Re: ALLSUP'S Convenience Store
9501 Gibson Blvd. SW
Traffic Circulation Layout
Engineer's/Architect's Stamp XX-XX-XX (M09-D034)

Based upon the information provided in your submittal received 04-12-23, the above referenced plan cannot be approved for Building Permit until the following comments are addressed:

SITE LAYOUT PLAN

C05.0

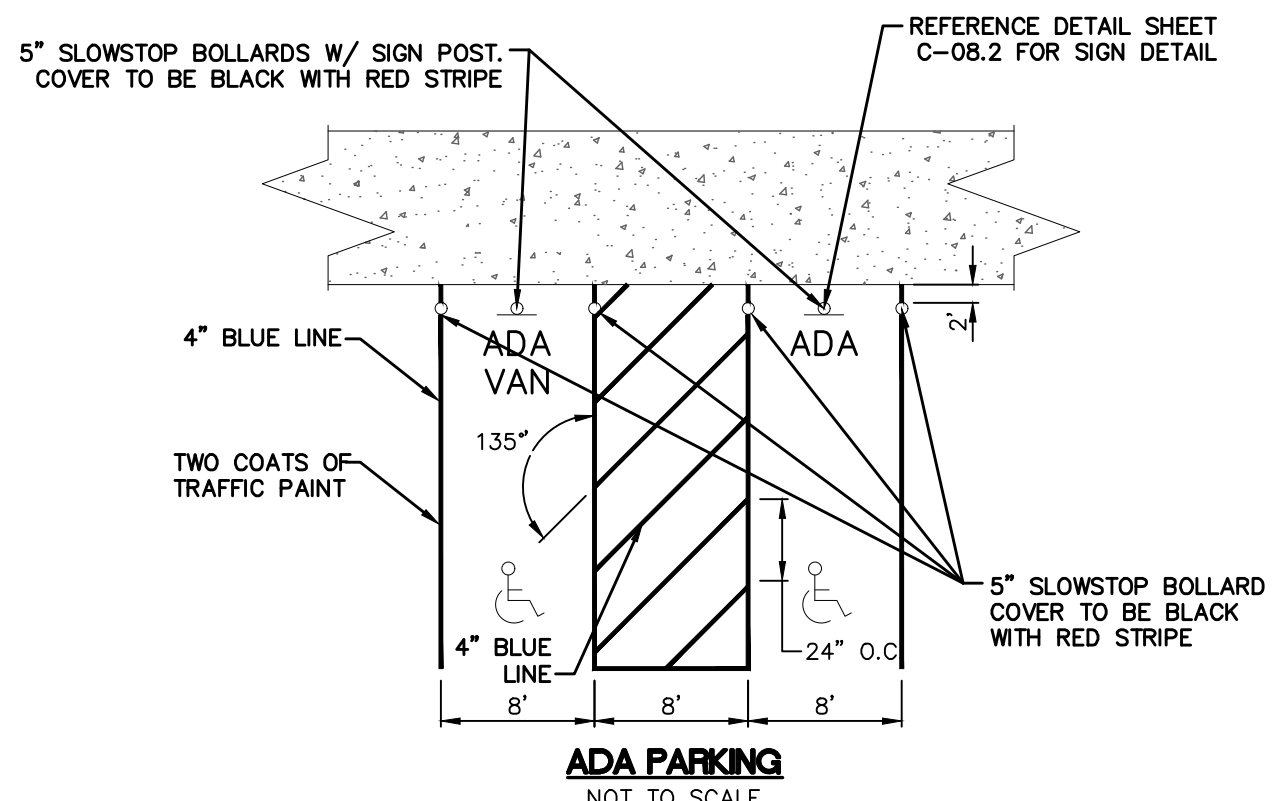
1. Please show a vicinity map showing the location of the development in relation to streets and well-known landmarks.
2. List the number of Motorcycle and Bicycle parking spaces required by the IDO.

3. The traffic circulation layout must be stamped, signed, and dated by an engineer or architect licensed in the state of New Mexico.
4. Identify all existing access easements and rights of way width dimensions.

5. Please provide approved DRC site plans showing the approval for the proposed Right Turn Lane off Gibson.
6. Please show on the site plan the buffer width off Gibson and 98th St.

7. Please provide design details for both proposed site accesses.
8. Provide details for all the proposed ADA ramps.
9. Please reference 2430 COA std dwg for the proposed sidewalk.

10. The ADA accessible parking sign must have the required language per 66-7-352.4C NMSA 1978 **"Violators Are Subject to a Fine and/or Towing."** Please call out detail and location of signs.

11. The ADA access aisles shall have the words **"NO PARKING"** in capital letters, each of which shall be at least one foot high and at least two inches wide, placed at the rear of the parking space so as to be close to where an adjacent vehicle's rear tire would be placed. (66-1-4.1. B NMSA 1978)

12. Motorcycle parking spaces shall be designated by its own conspicuously posted upright sign, either free-standing or wall mounted per the zoning code.

13. The pavement marking "MC" should be shown in the opposite direction for motorcycles entering the parking space.
14. All bicycle racks shall be designed according to the following guidelines:

15. Bicycle racks shall be sturdy and anchored to a concrete pad.
 16. A 1-foot clear zone around the bicycle parking stall shall be provided.
 17. Bicycle parking spaces shall be at least 6 feet long and 2 feet wide.

18. Per the IDO, a 6 ft. wide ADA accessible pedestrian pathway is required from the public sidewalk to the building entrances. Please clearly show this pathway and provide details.

19. Per DPM, a 6 ft. wide ADA accessible pedestrian pathway is required from the ADA parking stall access aisles to the building entrances. Please clearly show this pathway and provide details.

20. ADA accessible pedestrian pathway should not be placed behind parking space or adjacent to a vehicular way. Vehicle and pedestrian/wheel chair conflicts should be avoided as much as possible.

21. Refuse vehicle maneuvering shall be contained on-site. The refuse vehicle shall not back into the public right of way.; provide a copy of refuse approval.

22. Please provide "One Way" and "Do Not Enter" signage and pavement markings for the One-Way site access off 98th St. Please show detail and location of posted signs and striping.

23. Please provide a sight distance exhibit
 24. Show the clear sight triangle and add the following note to the plan: "Landscaping and signage will not interfere with clear sight requirements. Therefore, signs, walls, trees, and shrubbery between 3 and 8 feet tall (as measured from the gutter pan) will not be acceptable in the clear sight triangle.

25. Please specify the City Standard Drawing Number when applicable.
 26. Provide notes showing what work is included and on the work order and the private work on site.

27. Work within the public right of way requires a work order with DRC approved plans.
 28. Please add a note on the plan stating "All improvements located in the Right of Way must be included on the work order."

29. Add a note stating "All broken or cracked sidewalk must be replaced with sidewalk and curb & gutter." A build note must be provided referring to the appropriate City Standard drawing.
30. Please provide a letter of response for all comments given.
31. Traffic Studies: See the Traffic Impact Study (TIS) thresholds. In general, a minimum combination of 100 vehicles entering and exiting in the peak hour warrants a Traffic Impact Study. Visit with Traffic Engineer for determination, and fill out a TIS Form that states whether one is warranted. In some cases, a trip generation may be requested for determination (**Contact Matt Grush: mgrush@cabq.gov**).
